## ADDENDUM #1

AUDREY J. WALTON STADIUM  
TRACK AND SOCCER SURFACE UPGRADE

PROJECT NUMBER: CP252172

Crockett Engineering Consultants  
1000 W. Nifong Blvd, Bldg #1  
Columbia, Missouri 65203

SITE PLAN

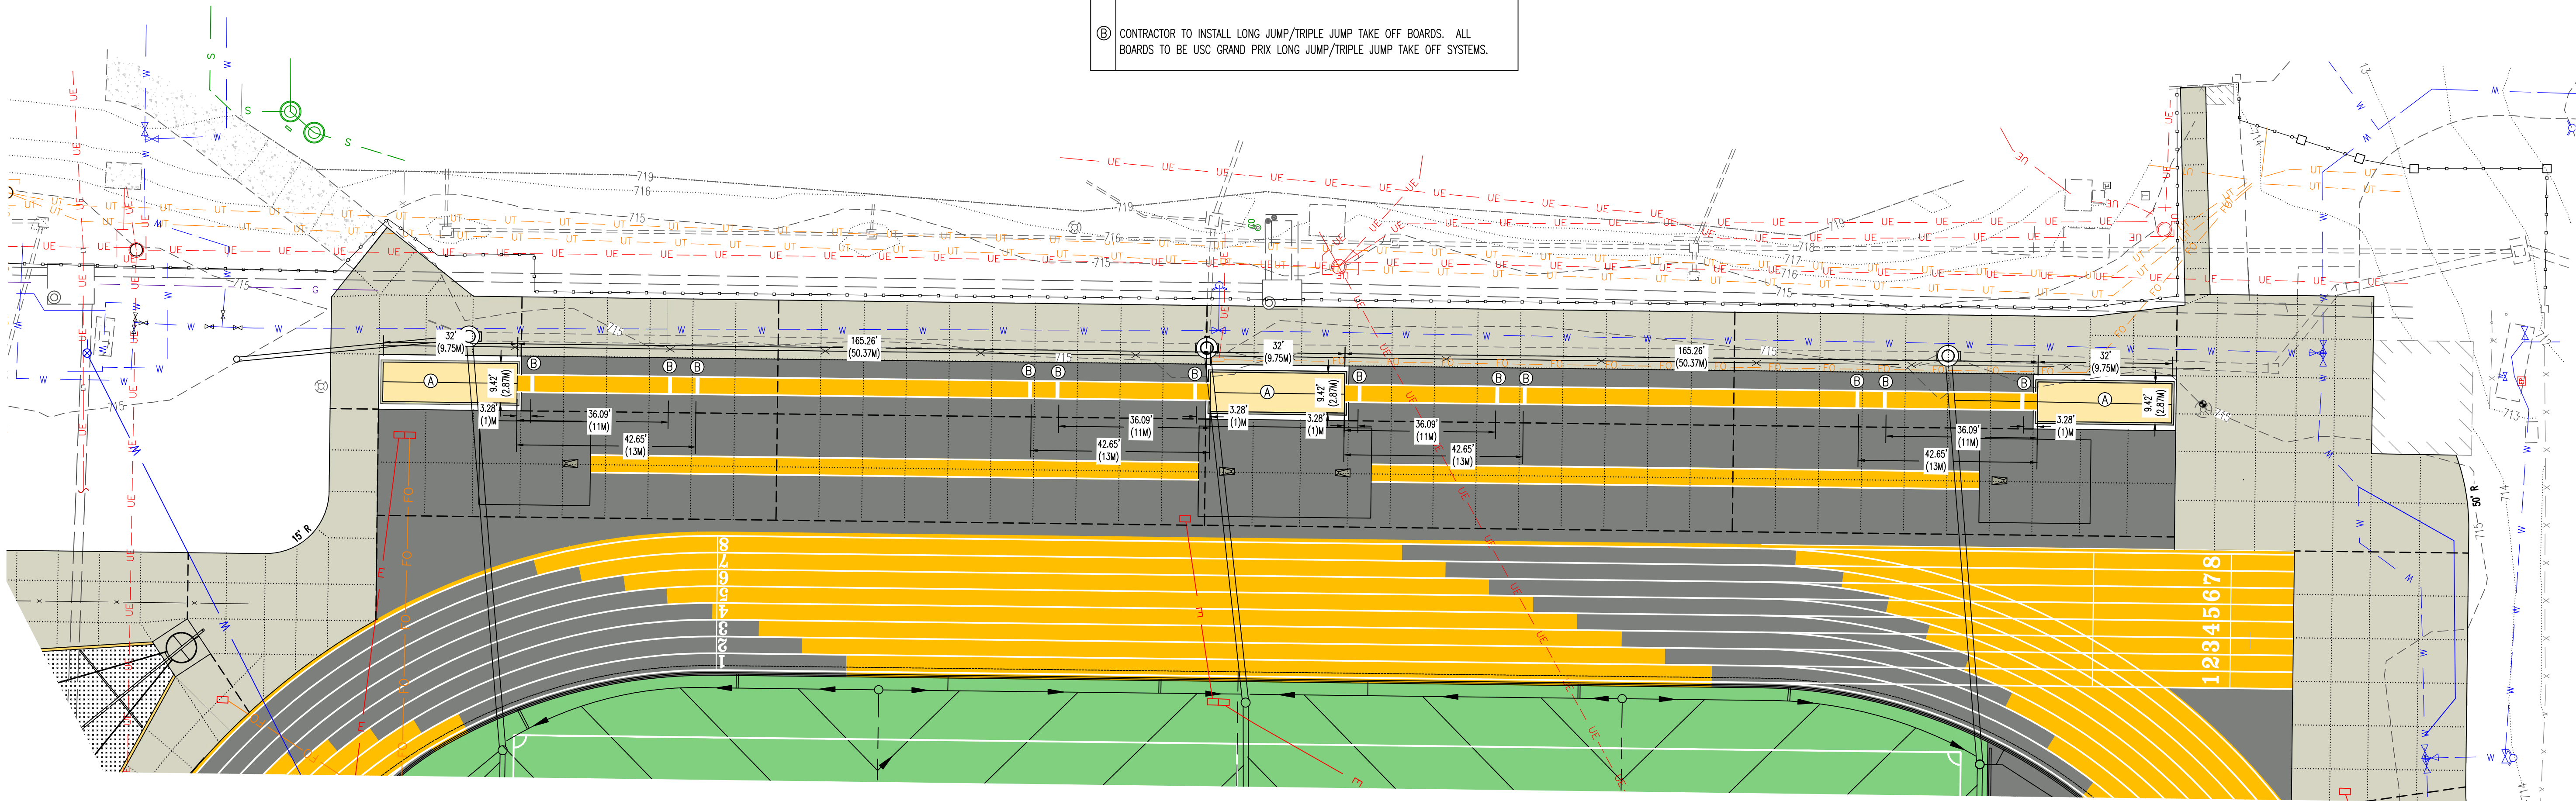
4. Comment: What water jump pit form is being specified?

10. Comment: Please confirm the quantity and locations of the brick columns as detailed on Sheet CE 7.3 and called out on Sheet CE 6.0, Note J. Note J is not called out on the plan.

26. Comment: Is the northwest corner of the track area that is labeled “G”, labeled incorrectly, and should read “C”?

28. Comment: Should the foundations for the pavilion that is located at the end of the northwest portion of the track, be shown on sheet CE 6.0?

See revised Note “M” on Sheet CE 6.0 with regards to the water jump pit form model number for the steeplechase. The Equipment and Supply Matrix on same page has been updated with same information.

There shall be 5 new brick and stone columns on this project. This is described in Note "J" on Sheet CE 6.0. The location is as identified on Sheet 6.0 at the southeast corner of the site. The naming arch above the entrance columns shall be reused and placed in/above the new entrance columns.

Yes. This label should read ”C”. This will be revised on the plans accordingly.

Yes. The foundations for the future pavilion, as called out by Note “T” on Sheet CE 6.0, should be shown as presented as they are a part of the Base Bid.

5. Sheet CE 6.0 – The addition of the water jump pit form information. This was added to note M as well as the Equipment and Supply Matrix. A label at the northwest corner of the track was revised from “G” to “C”.

SHEET:  
S100

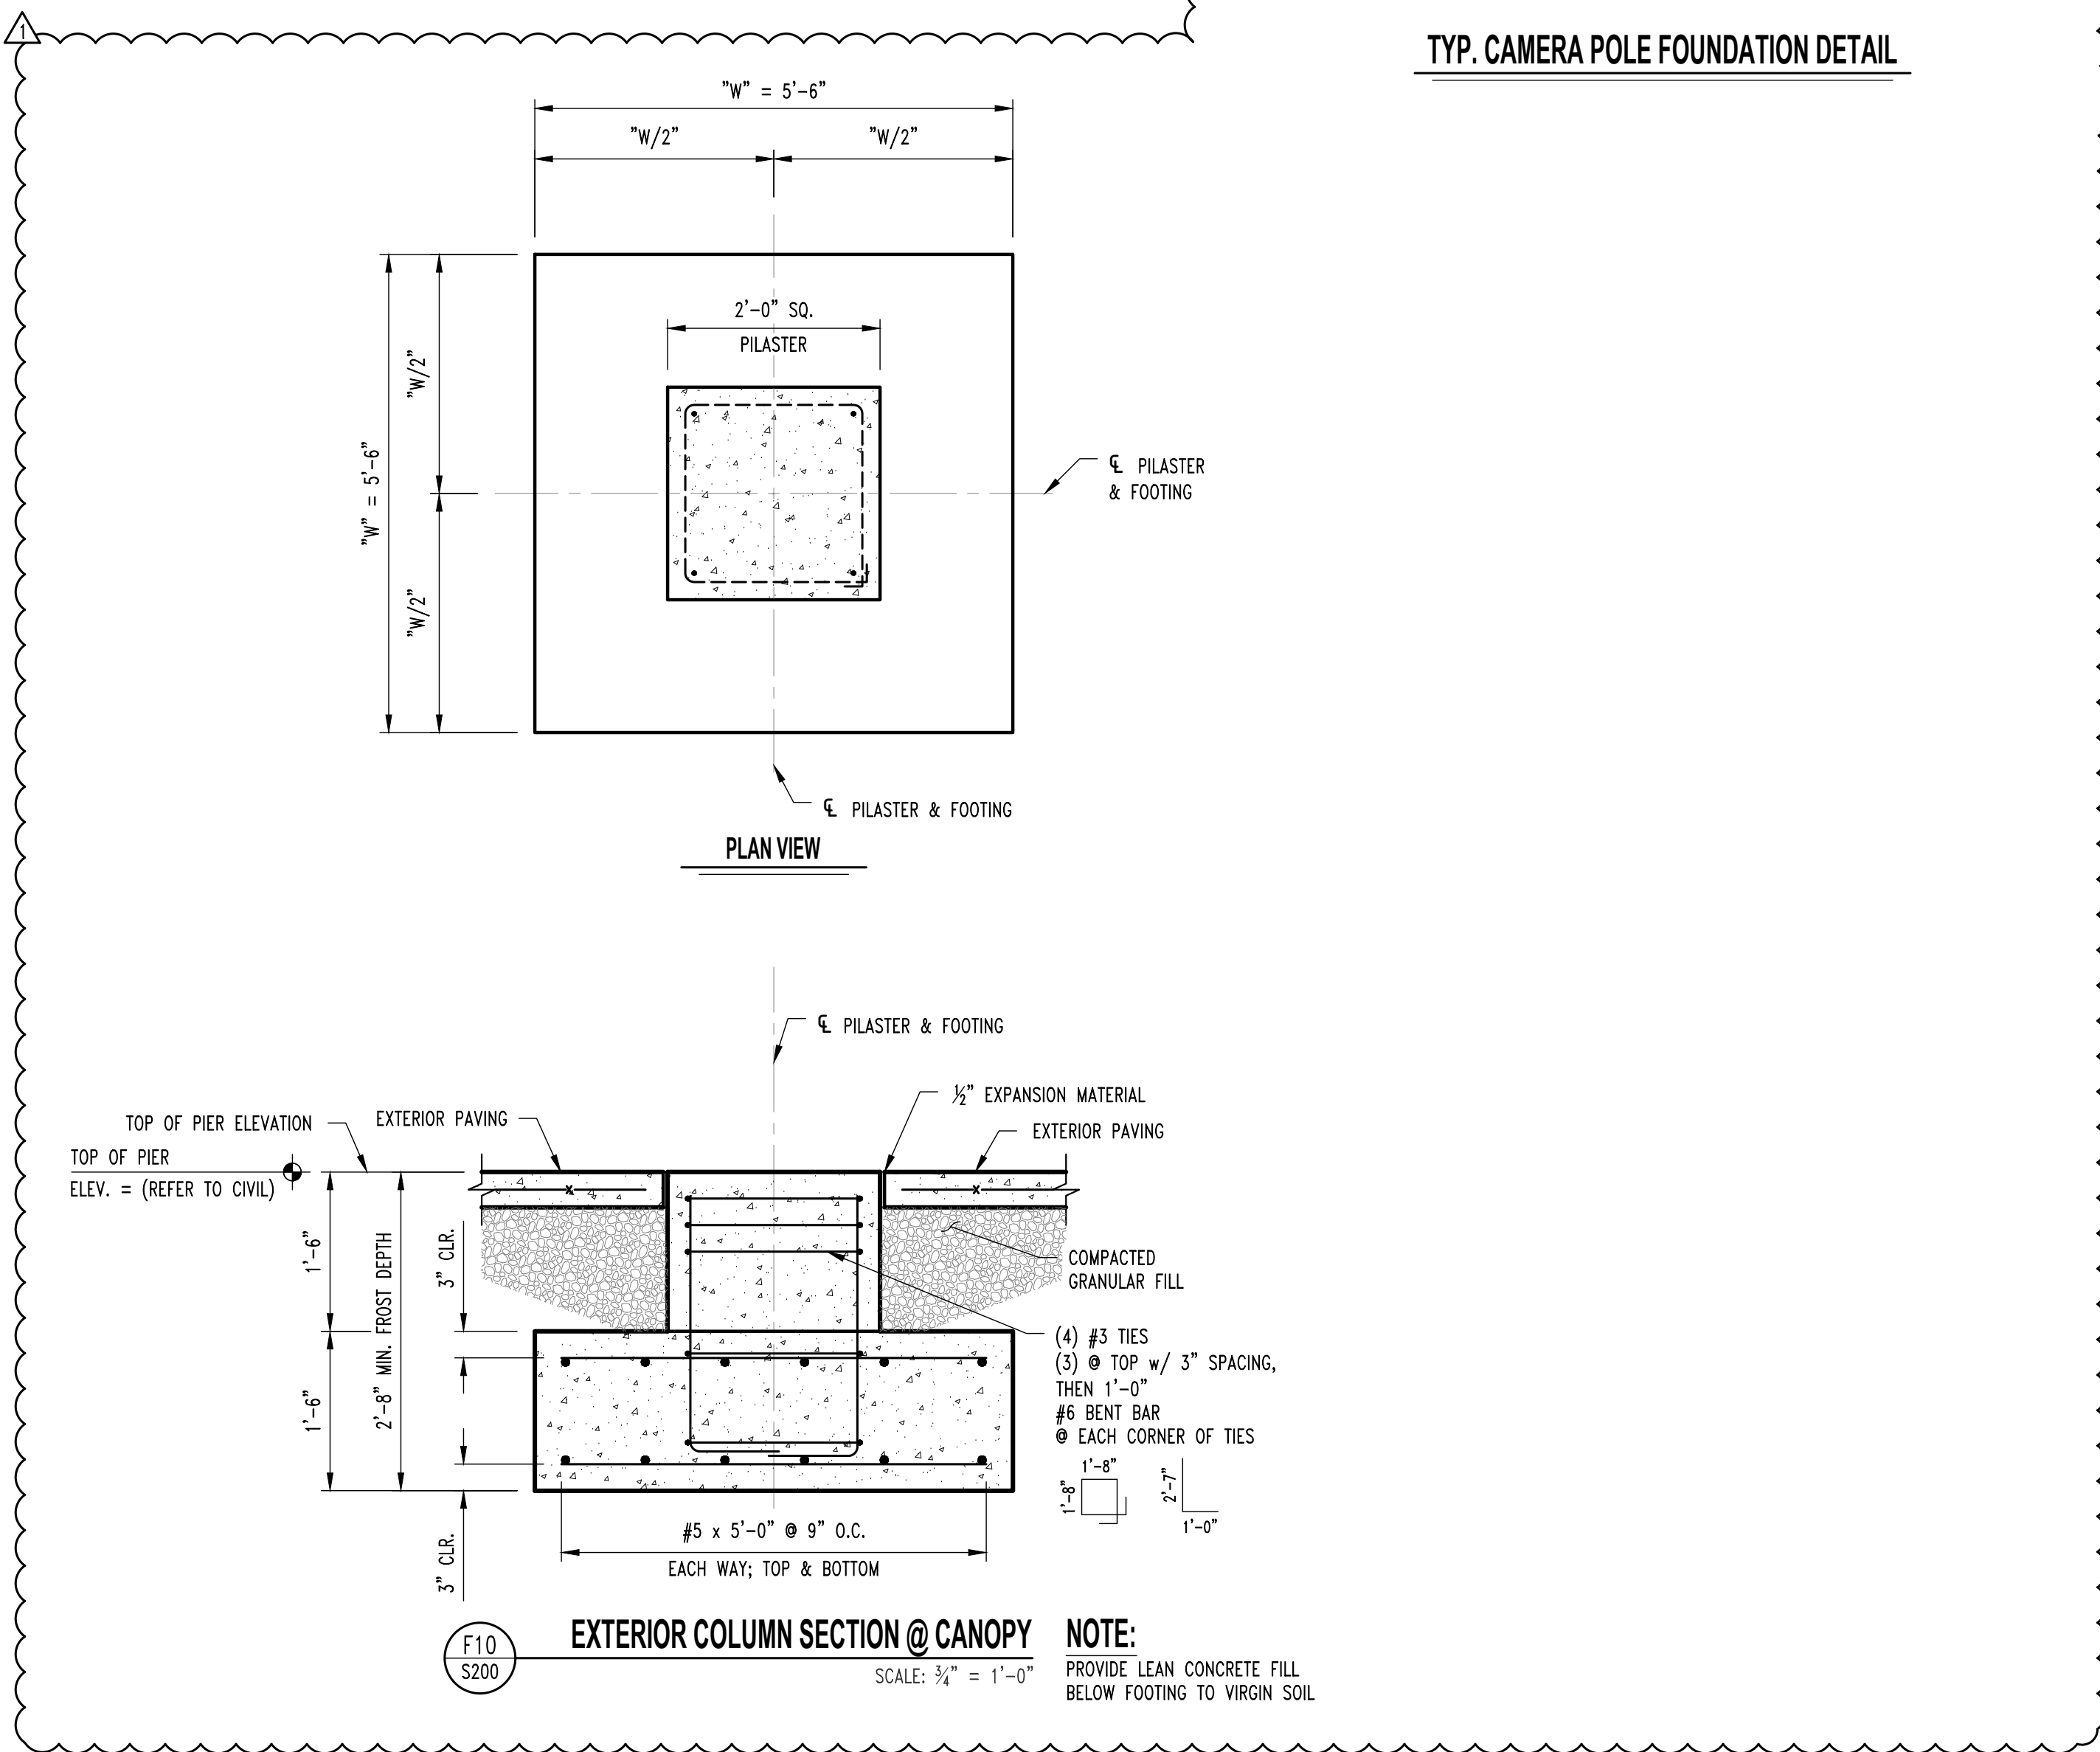
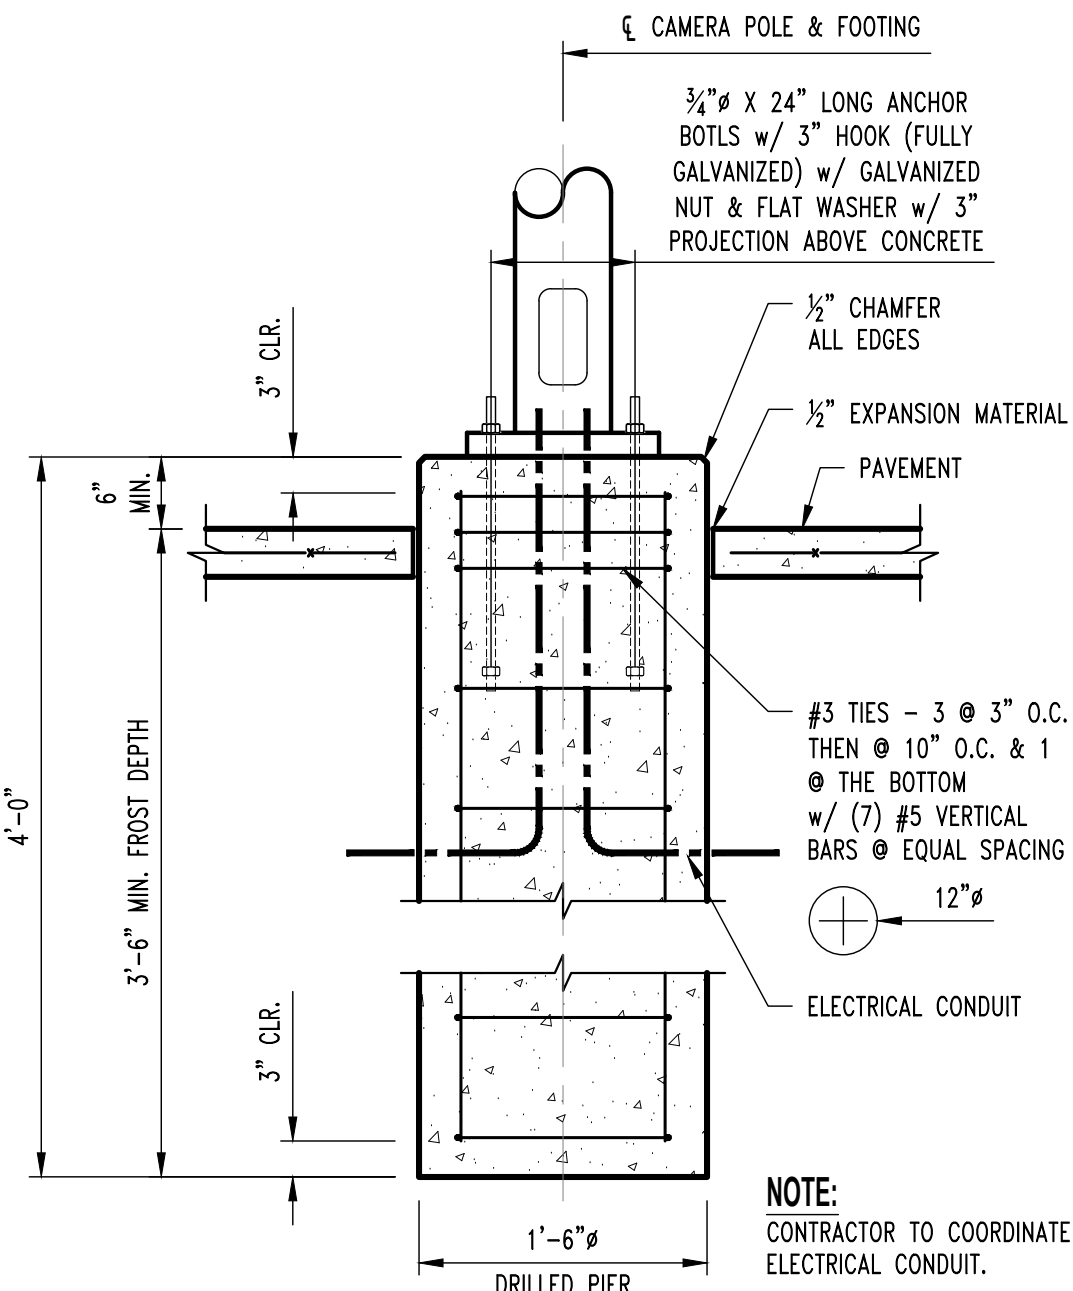
12. Comment: Please provide details for the pole mounted replay camera base and footing called out on CE 4.0, Note P.

A detail has been added to Sheet S200. Note P on Sheet CE4.0 has been revised to show 3 relocated bases are needed rather than 4.

8. Sheet CE 8.0 – Revised to show the existing field goal post.
9. Sheet S100 - Removed unneeded specifications and updated special inspections
10. Sheet S200 – Updated plan dimensions, added plan note, updated detail F10, and added Typ. Camera Pole Foundation Detail
